HOMES NSW

29 FLORIDA STREET  
SYLVANIA (SSD-83258708)

RESPONSE TO SUBMISSIONS

REVISION 04

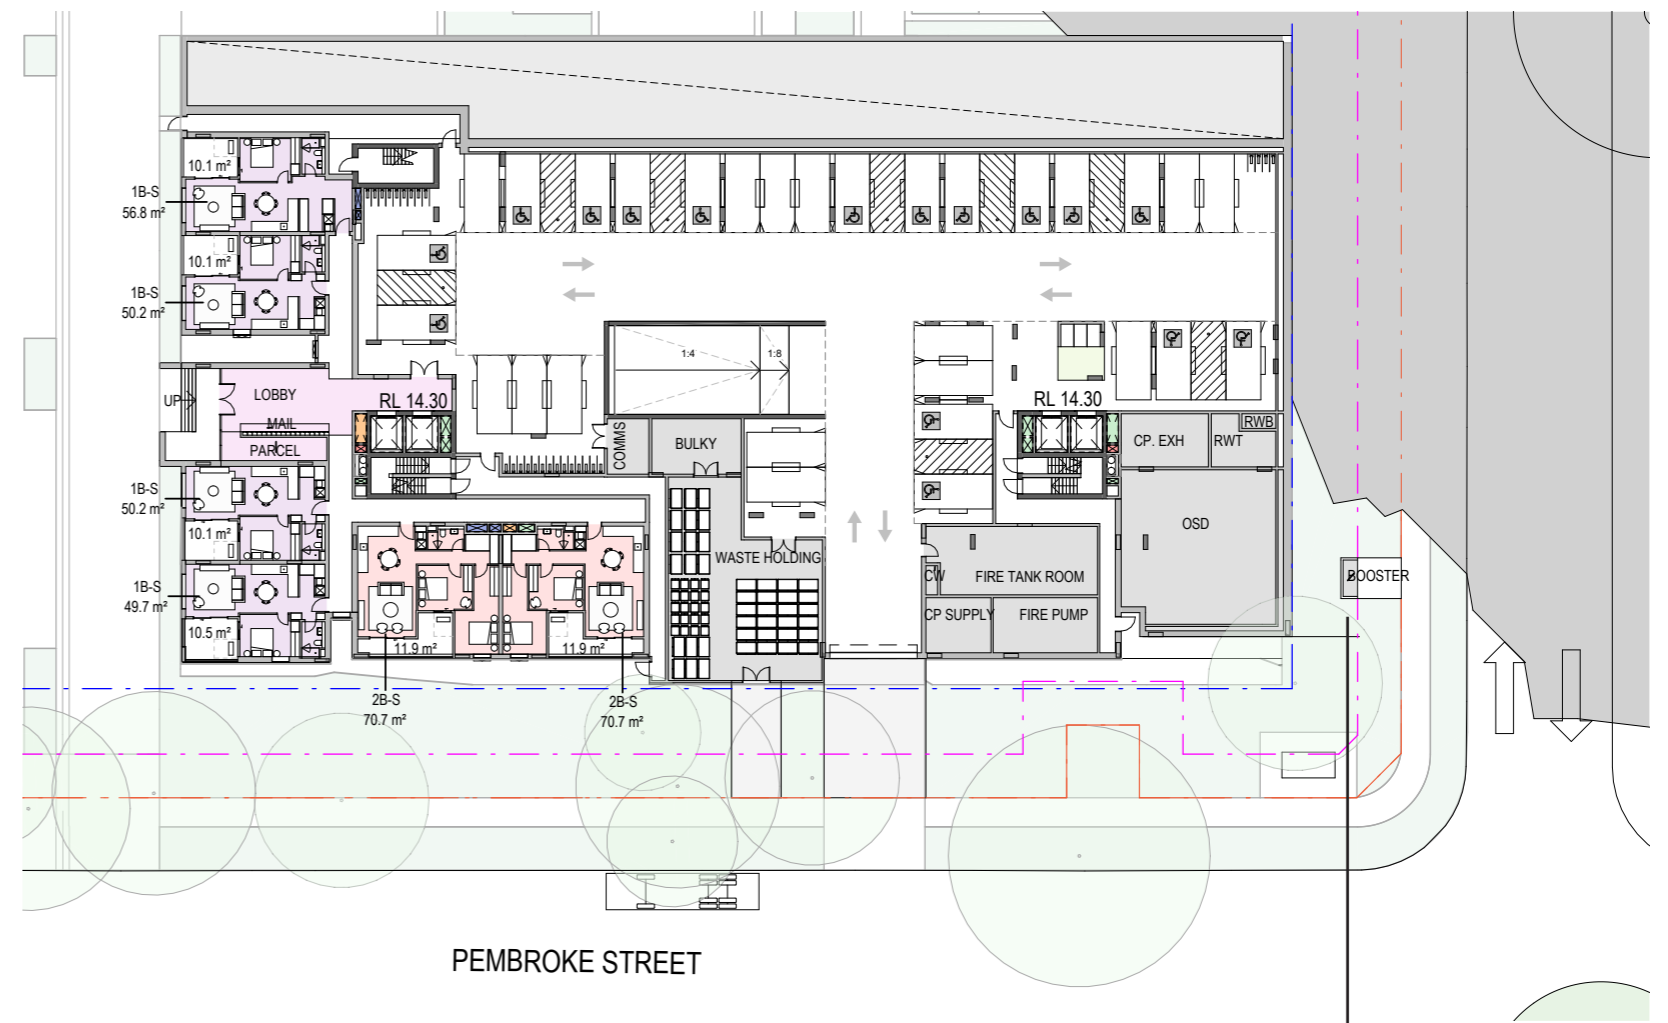
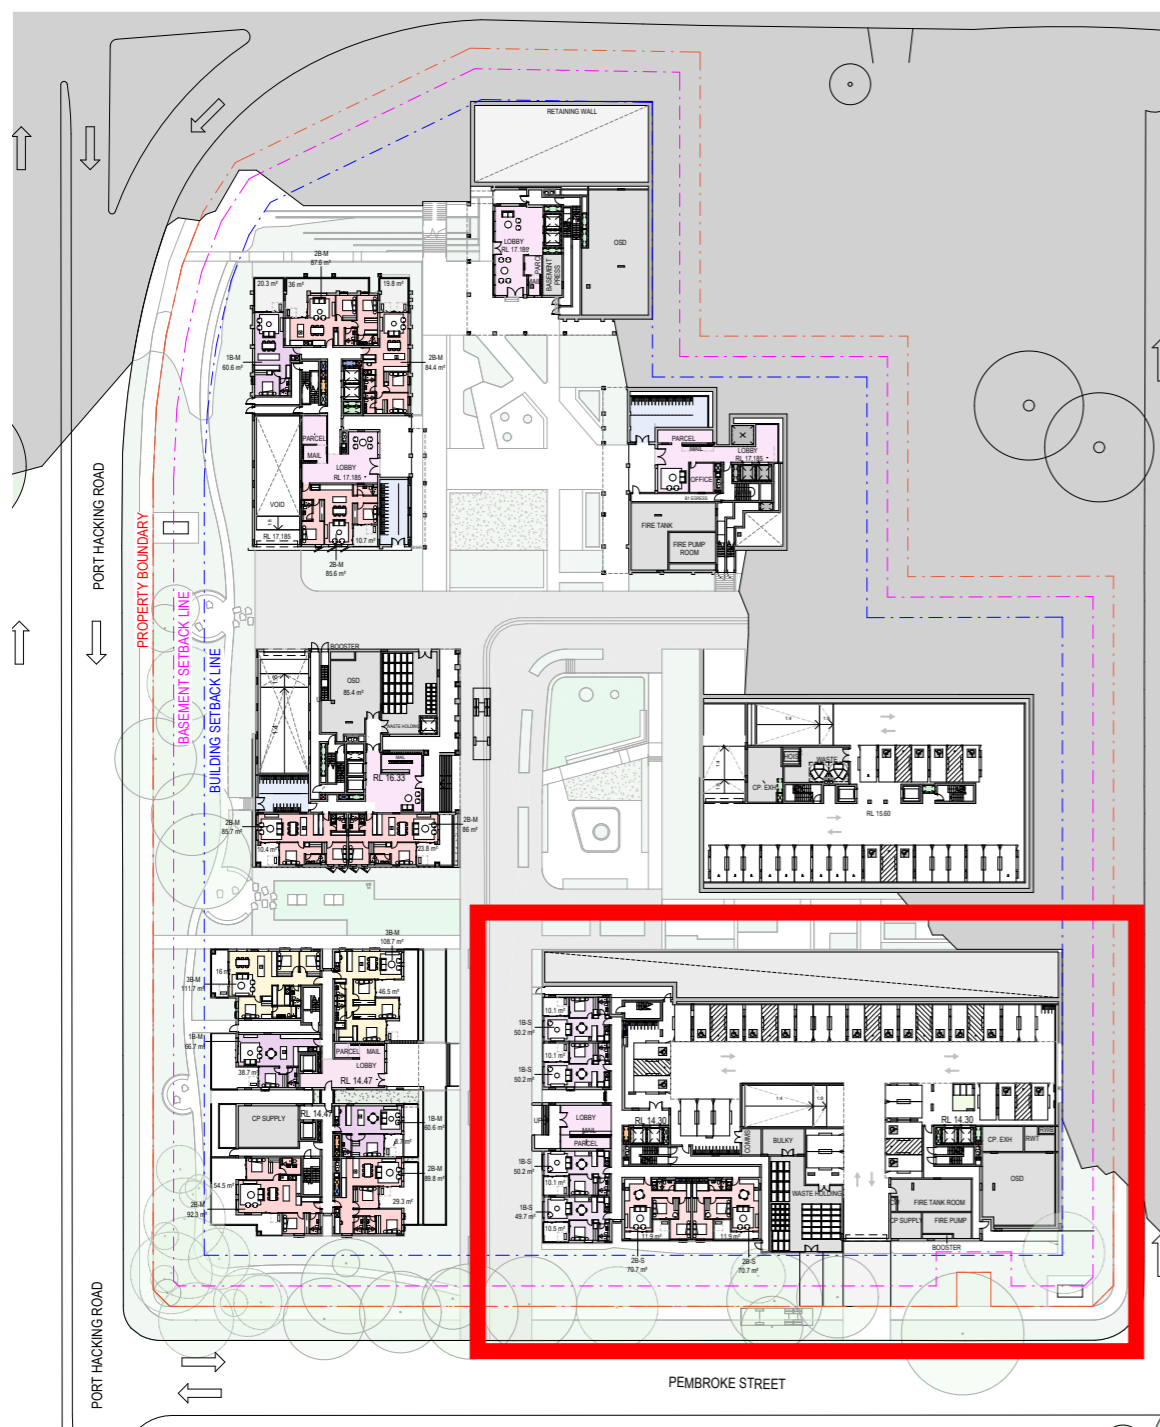
8.1	<p>A Fire Hydrant Services Report must be prepared that assesses NSW Fire and Rescue’s fire hydrant requirements for the development, having regard to the outcomes of the localised options and hydraulic assessment to confirm that a ‘suction’ connection is not required.</p>	<p>Further coordination with Fire Service Engineers JHA has been undertaken to refine the quantity and location of fire booster pumps and associated fire tank rooms. This has been reflected in the report provided by JHA. The resulting changes have been made as per the below diagrams. The number of fire boosters provided for the precinct has been reduced to 2, one for each title. The social housing booster has been relocated from within the bulding to be along Florida Street, within acceptable distance of the fire tank and pump room and more than 10m away from the substation while also ensuring there is no impact to existing significant trees. The fire tank and pump rooms serving the market housing developments have all been consolidated into Market Building 1C, with a booster inside the bulding footprint within 8m of the internal road. This has allowed for an additional apartment to be added into Market Building 2 where there used to be a fire tank and pump room, and additional sotrage and plant areas in Market Building 3A where the fire tank and pump room used to be in the basement.</p>

FIRE BOOSTER HAS BEEN RELOCATED FROM WITHIN THE BUILDING FOOTPRINT IN THE SOCIAL HOUSING COMPONENT OF THE DEVELOPMENT, TO BE OUTSIDE OF THE BUILDING ON FLORIDA STREET
